Access Compliance Report

Public Rights-of-Way

(Curb Ramps)

Intersection ID: 32201	Main Street: HUXLEY_RD	Cross Street: REAVENCREST_PARK_DR	Location: SE
ADA ID: D451C5259071	Ramp Type: PerpDiag	Initial Pass/Fail: Fail	Overall Compliance: No
Severity Score: 8.75			
Codes/Mitigation Info/Possible Solution		Field Measurements/Component Compliance

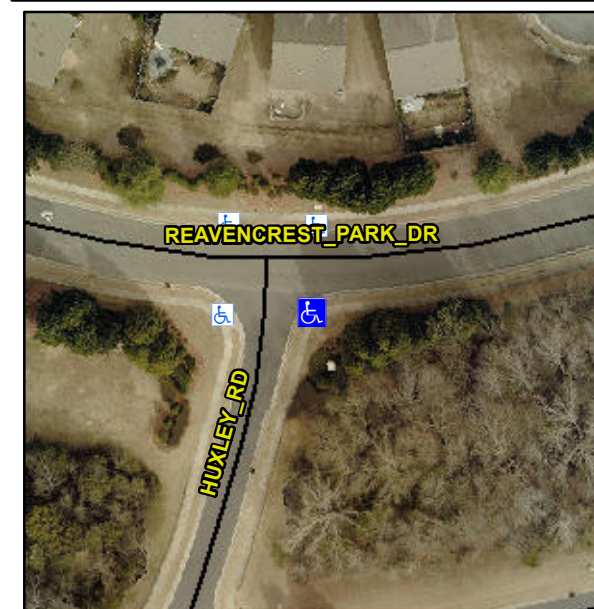
Not Found, R304.5.1

Compliance	Description	Data	Compliance	Description	Data
N/A	Ramp Length (in)	96.0	Yes	Ramp Slope (%)	7.2
No	Ramp Width (in)	40.0	Yes	Ramp XSlope (%)	0.2
N/A	Flare Type LT	N/A	N/A	Flare Type RT	N/A
N/A	Flare Slope LT (%)	N/A	N/A	Flare Slope RT (%)	N/A
N/A	Flare Traversable LT?	N/A	N/A	Flare Traversable RT?	N/A
N/A	Landing Length (in)	N/A	N/A	DWS Provided?	N/A
N/A	Landing Width (in)	N/A	N/A	DWS Contrast?	N/A
N/A	Landing Slope (%)	N/A	N/A	DWS Length (in)	N/A
N/A	Landing X Slope (%)	N/A	N/A	DWS Full Width?	N/A
N/A	Landing Curb? (Y/N)	N/A	N/A	DWS Offset (in)	N/A
N/A	Shared Landing?	N/A			
N/A	Gutter Ponding?	N/A	N/A	Gutter Slope (%)	N/A
N/A	Gutter Lip Ht (in)	N/A	N/A	Gutter X Slope (%)	N/A
N/A	Painted X Walk1?	No	N/A	Painted X Walk2?	No
	X Walk 1 Direction	To N		X Walk 2 Direction	To W
N/A	X Walk 1 Width (in)	N/A	N/A	X Walk 2 Width (in)	N/A
	X Walk 1 Slope (%)	4.0		X Walk 2 Slope (%)	1.1
	X Walk 1 X Slope (%)	1.2		X Walk 2 X Slope (%)	5.4

Remove & Replace Curb Ramp With Two New Directional Ramps or Equivalent.
